**City of Bellevue  
Department of Planning & Community Development  
Land Use Division Staff Report**

**Proposal Name:** Newport Estates Preliminary Short Plat

**File Number:** 06-109501-LN

**Department Decision:** **Approval with Conditions**

TITLE: PLOT PLAN - PRELIMINARY SHORT PLAT  
 PROJECT: NEWPORT ESTATES, FOR MINKS, INC.  
 ADDRESS: 13339 SE NEWPORT WAY, BELLEVUE, WA  
 DESCR: PRELIM. 3 LOT SHORT PLAT  
 Design: Campbell Construction Engineering, LLC  
 Richard Campbell, PE  
 21421 NE 25th Pl.  
 Redmond, WA 98053  
 425-688-6589

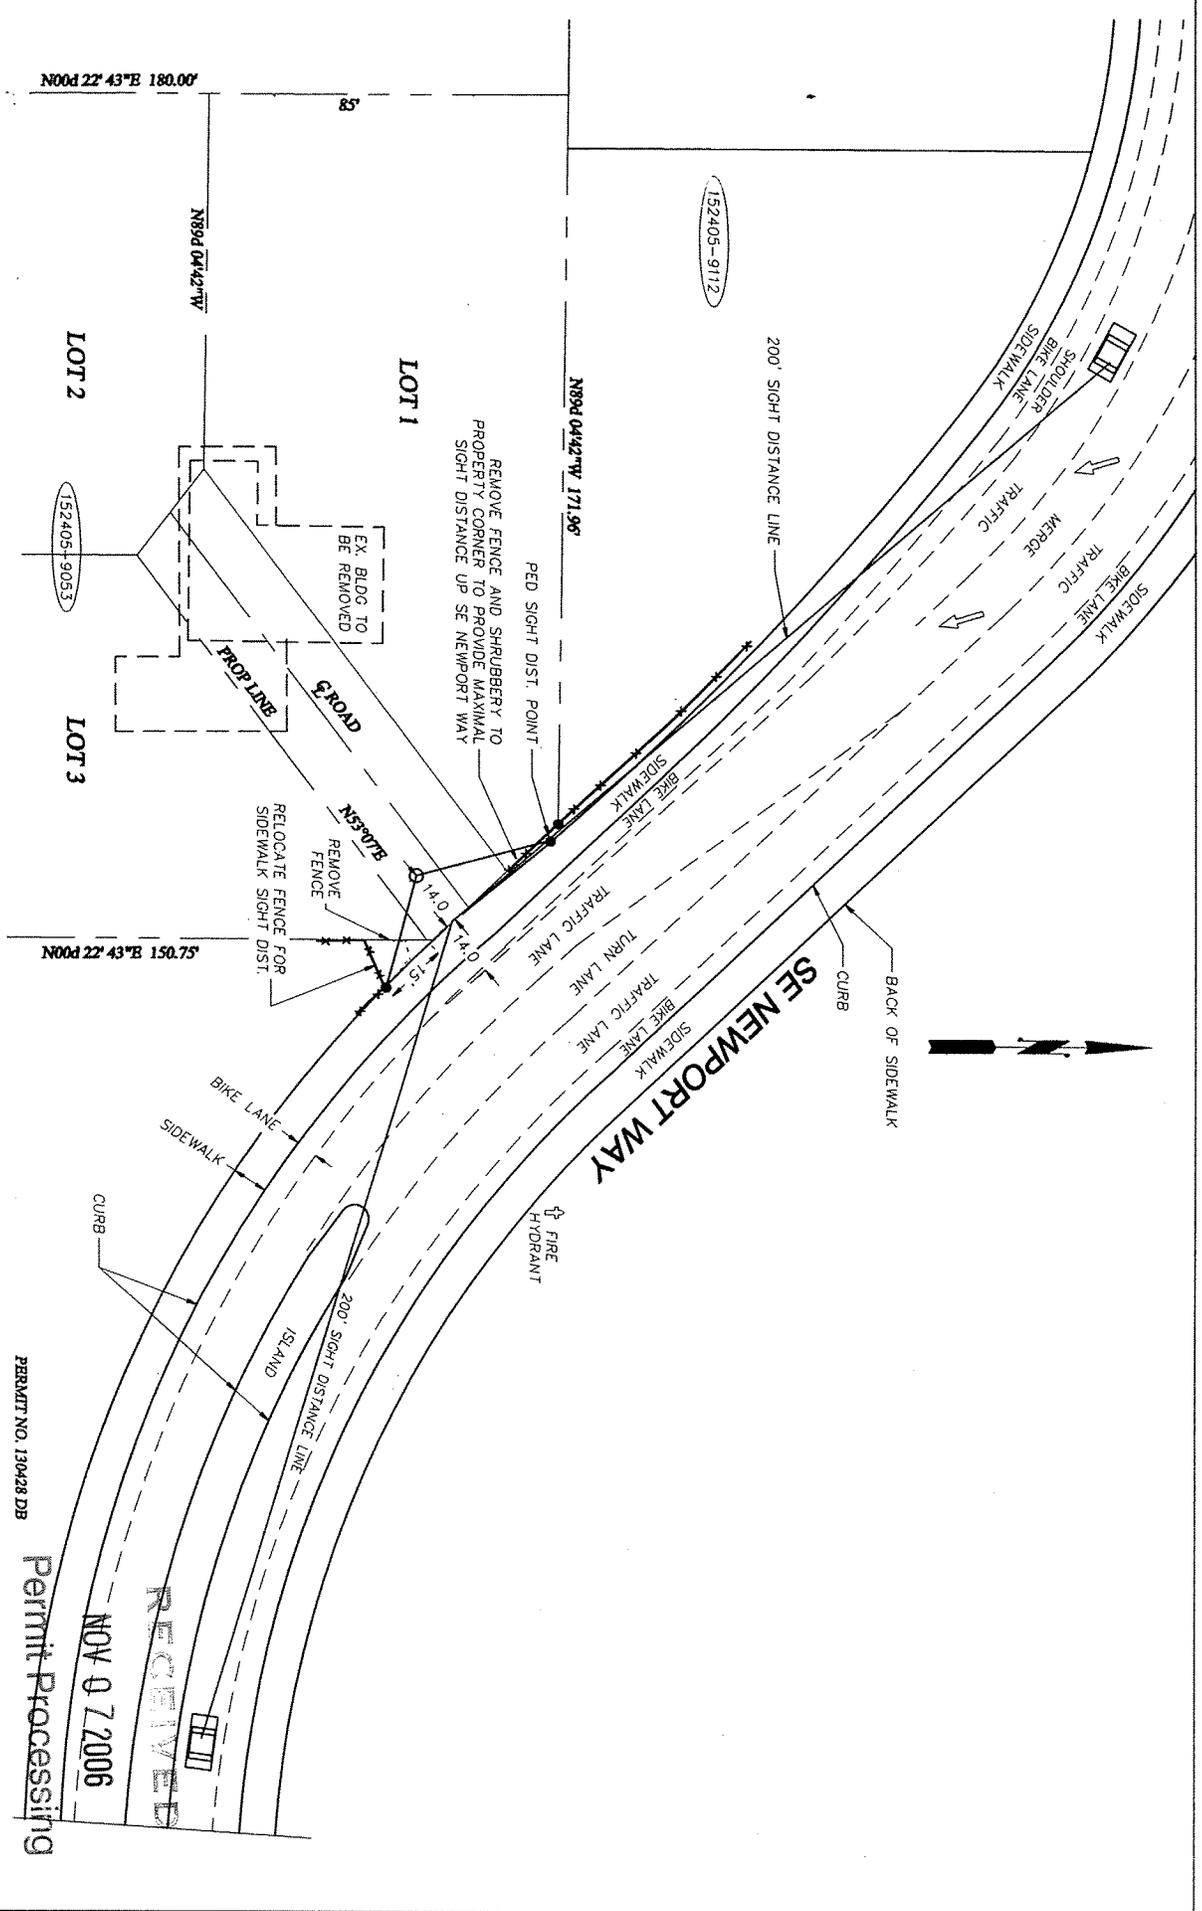
**Finding:** As conditioned, the proposal complies with the Land Use Code requirements for R-3.5 zoning, the Utility Code and the City of Bellevue Development Standards. Lot 3 will need to change the lot depth from 79 feet to 80 feet. See condition IX.C.2.

The final short plat shall portray a minimum of 80 feet for the lot depth for Lot 3.
